1997 - 2000 Corvette: Service Bulletin: Inaccurate/Erratic Fuel Level Gauge Readings

Number: 01-06-04-022

Subject: Inaccurate/Erratic Fuel Level Gauge Readings (Install New Sensor, Strainer and/or RH Fuel Sender Assembly)

Model Year: 1997-2000 Chevrolet Corvette

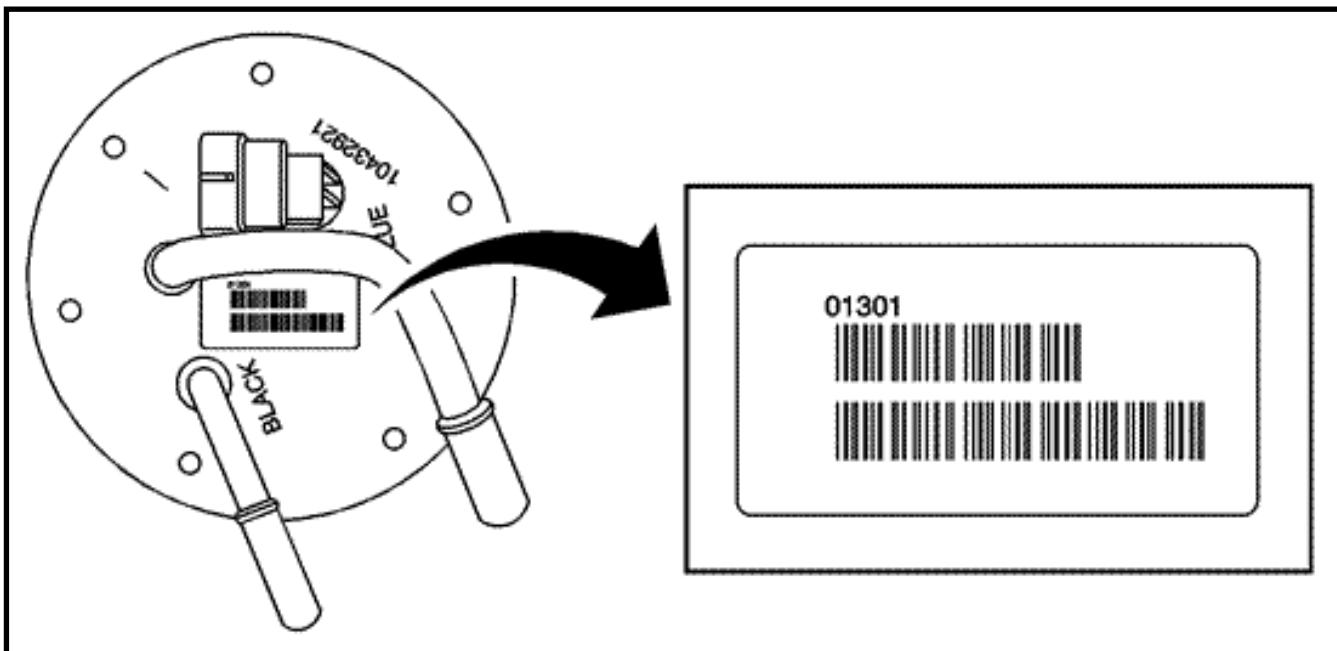
Inspect the Julian date codes located on the bar code labels attached to the R.H. and L.H. fuel level sender assembly cover plates as shown in the figure. If the R.H. sender date code is less/smaller than "01301", replace the complete assembly with a new fuel sender kit indicated below by model year. If the L.H. sender date code is less/smaller than "32791", replace the existing fuel sender sensor and strainer with those components contained in the applicable sensor and strainer kits shown below by model year.

Part Number	Description
88896043	R.H. Fuel Sender Kit (1997-1999 M.Y.)
88895126	R.H. Fuel Sender Kit (2000 M.Y.)
88899034	Fuel Sensor Kit (1997-2000 M.Y.)
12458245	Fuel Strainer Kit (1997-1999 M.Y.)
12459862	Fuel Strainer Kit (2000 M.Y.)
